GFA AIRWORTHINESS DIRECTIVE

TYPE AFFECTED: Glasfluegel Kestrel, all serial numbers.

SUBJECT: Airbrake actuating shaft.

Flight Controls - airbrakes actuation shaft

BK - Antriebswelle
 Air brake actuating shaft

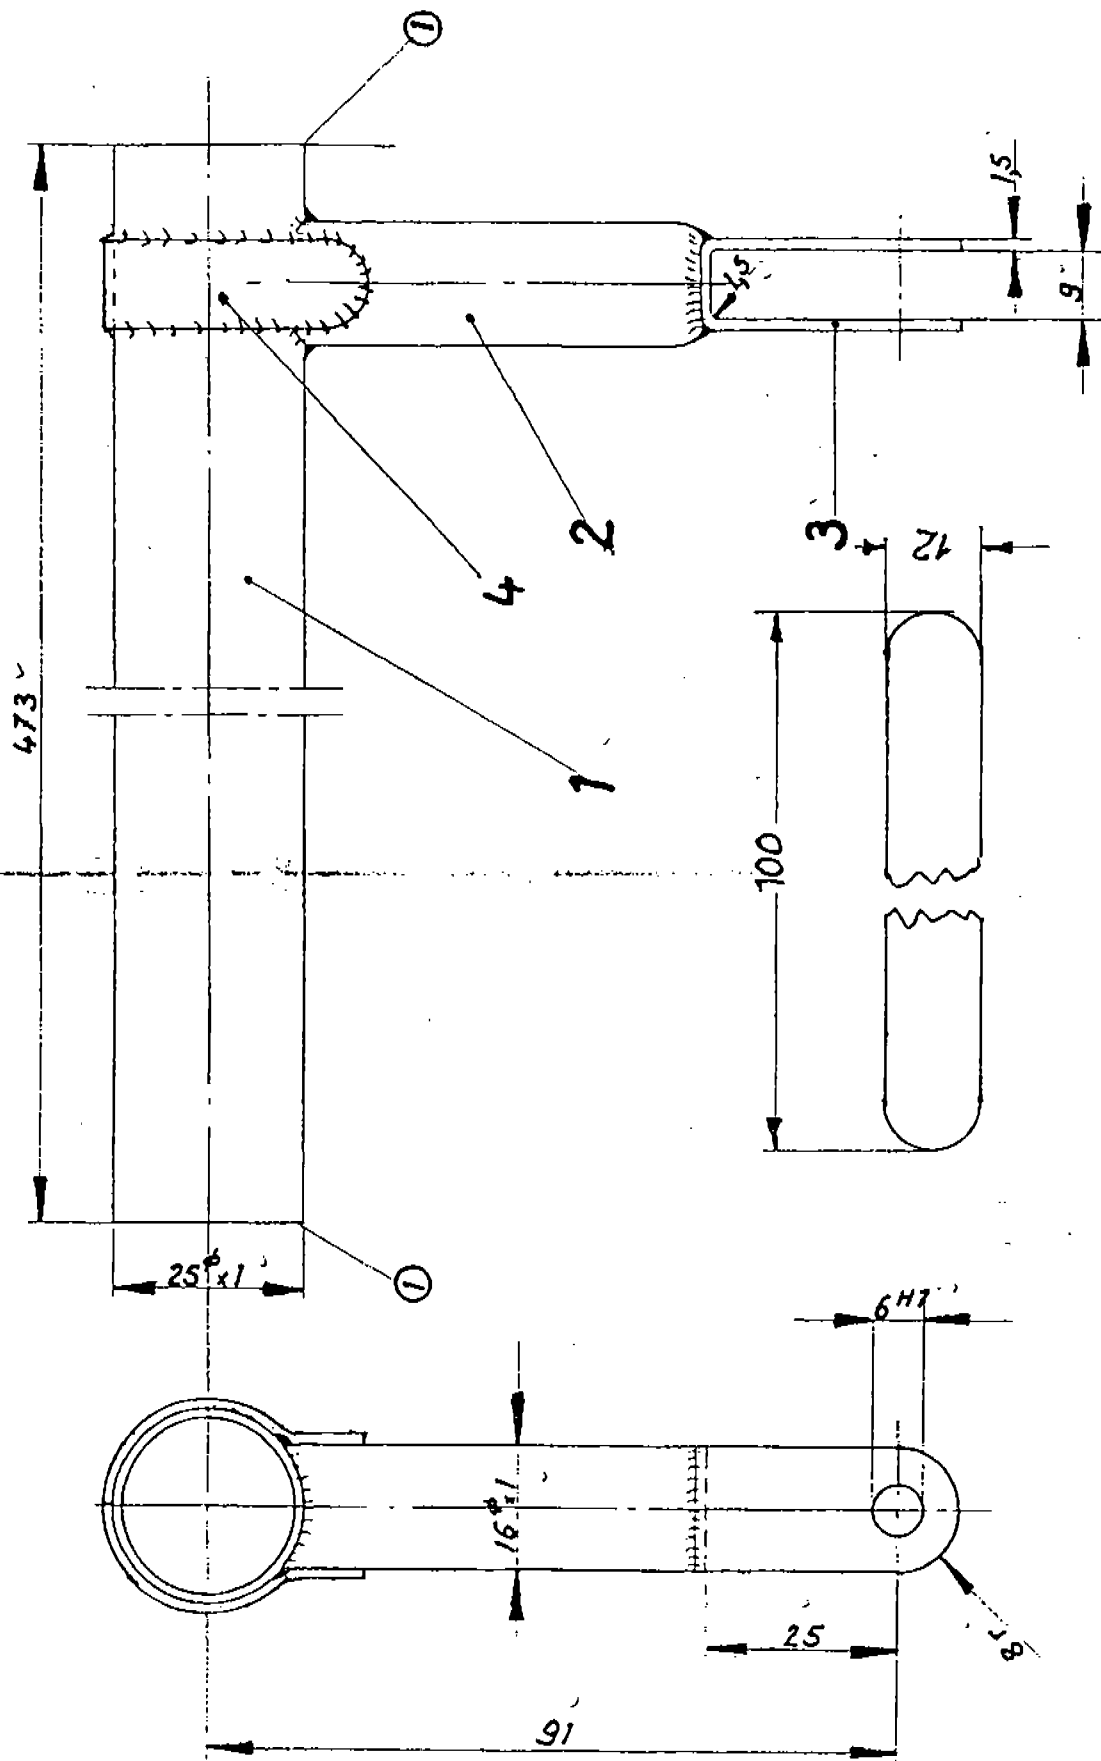
1. Visually check the area of the welding seam between actuation lever and torsion shaft
2. Insert page 27d into the flight manual
3. Visually check the area mentioned in step 1 at each annual inspection

4. If damage is found during completion of step 1 or 3, the airbrake actuation shaft must be immediately removed. The welding seam area must be thoroughly cleaned and all paint removed. In case of visible deformation, the actuation lever must be heated and returned to the original position. Visible cracks may only be welded by a licensed aircraft welder within a licensed and appropriately equipped aircraft maintenance organisation. Afterwards no. 4 must be properly welded in accordance with drawing no. 401-56-3-1.
Welding joints must be done with the WIG-inert protective atmosphere welding system with welding material 1.7734.2. Finally the actuation shaft must be finished with primer and paint RAL 7003. After assembly, you must check that both airbrakes are completely locked and past the over center. This can be done by visually inspection through the hole in the root rib both airbrake actuators must be positioned against their stops.

At the same time the airbrake handle should be in the detent. The force needed to lock and unlock the spoilers should not be more than 20 daN (44lb). If the forces are too high, the length of the control rod in the fuselage may need to be adjusted.

Material: See drawing no. 401-56-3-1
